Subject: Lodi Energy Center (08-AFC-10)
Data Response Set 6, Responses to CEC Staff Requests 1 and 2

LODI ENERGY CENTER

Data Responses, Set 6

(Staff Requests 1 and 2)

FIGURE SR-2
AREAS SURVEYED FOR
PROPOSED OFF-RAMP
 LODI ENERGY CENTER
 LODI, CALIFORNIA

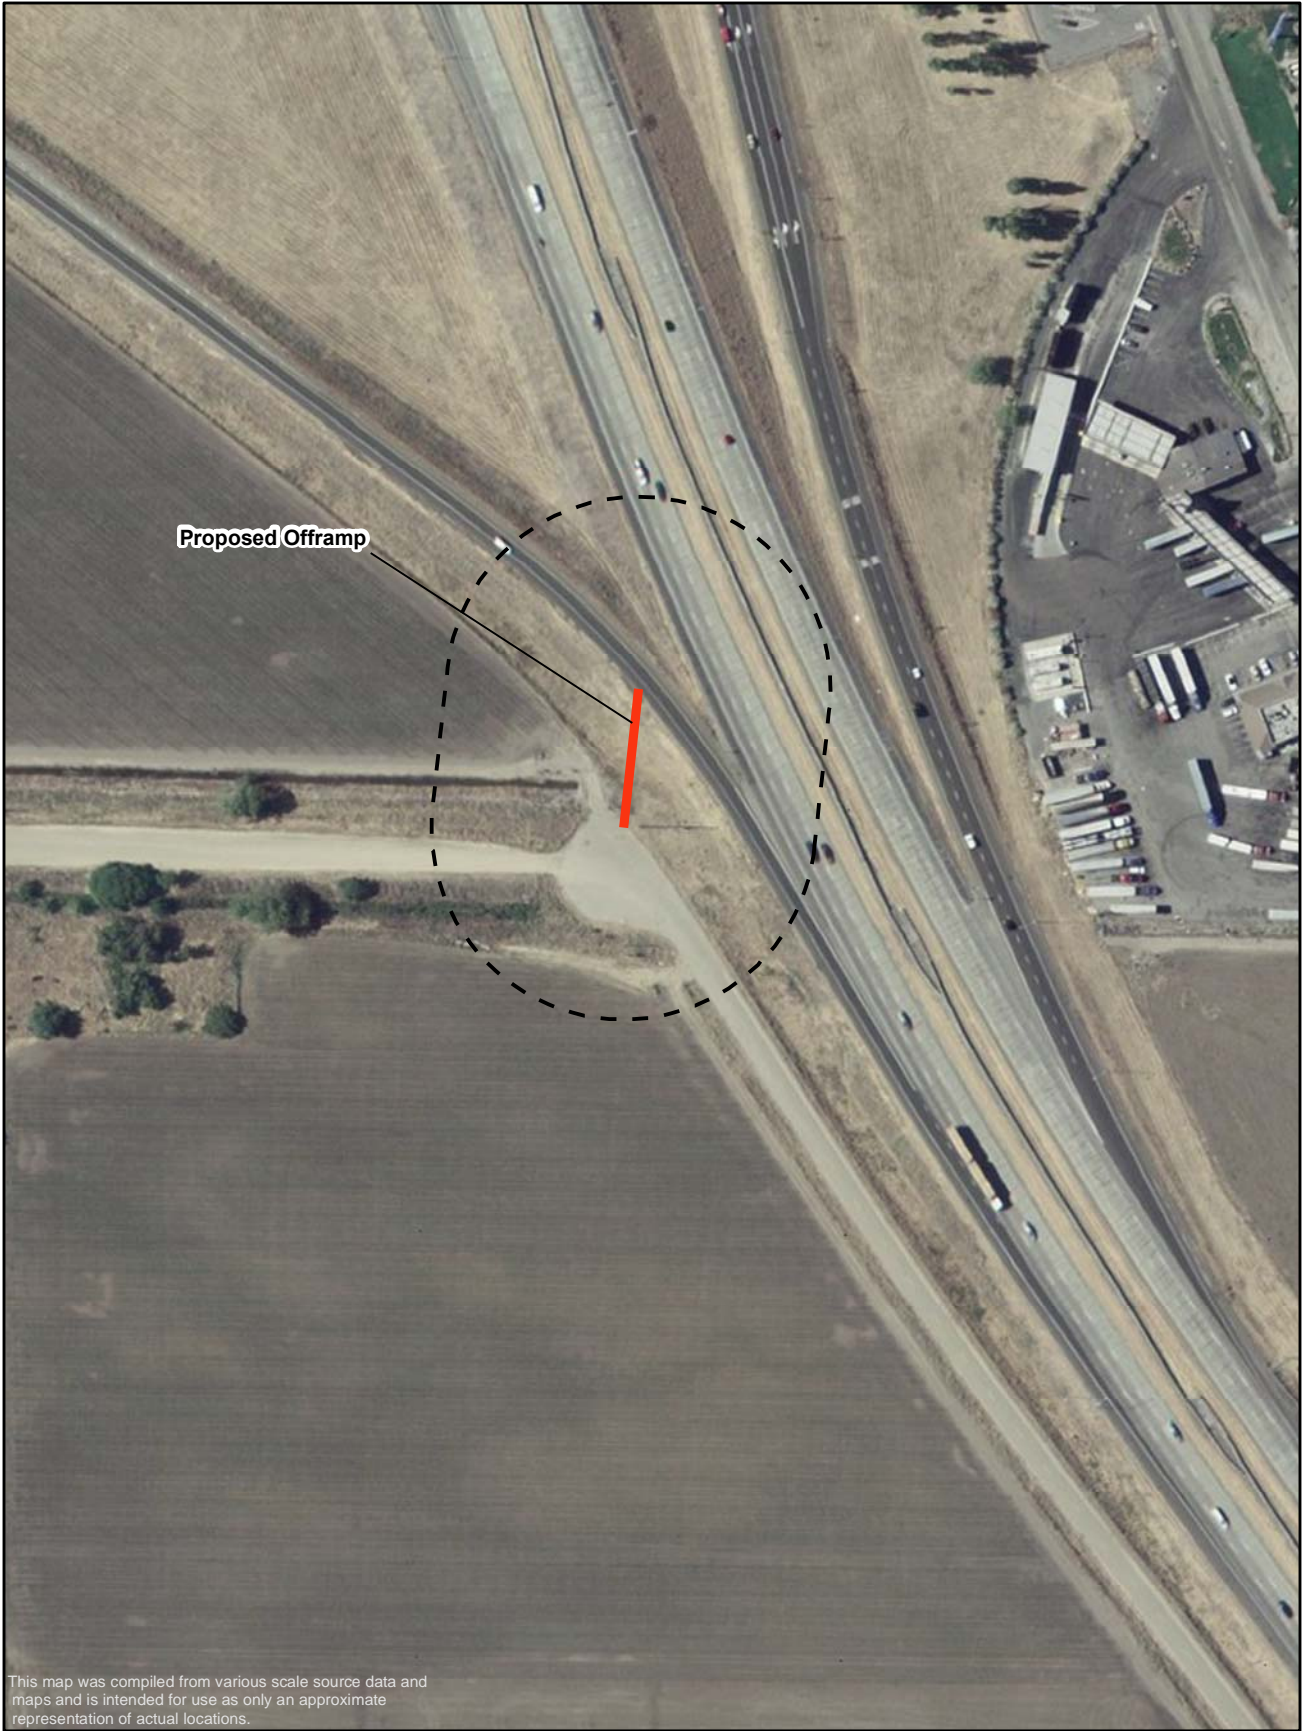
2. Please provide a map that identifies the off ramp survey area.

Response: Figure SR-2 identifies the proposed off-ramp, and the survey buffer area.
